CLIO 2

88C PASSENGER AIR BAG MODULE MOUNTING
OTS: 0A3R MARK: A5

Passenger air bag module mounting

Fig. 1

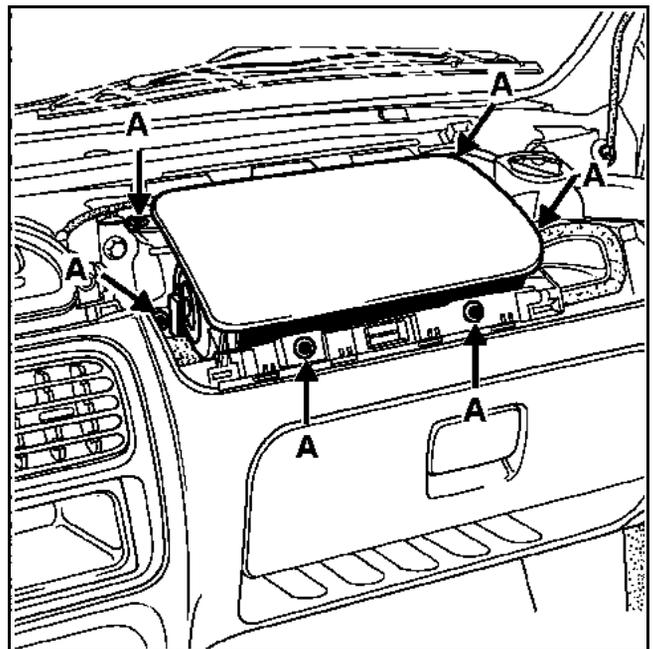
- Lock the air bag computer as described in the Air bag manual, using the diagnostic tool.
- Remove the windscreen pillar trims.
- Remove the two half cowlings under the steering wheel.
- Remove the mounting bolts from the upper section of the dashboard.
- Remove the upper section of the dashboard.
- Check the passenger air bag module mounting: The mounting must be held by 6 bolts (A) (**Fig. 1**) (tightening torque **0.6 daNm**).
- Refit the upper section of the dashboard.
- Unlock the air bag computer.

A - Passenger air bag module mounting bolt
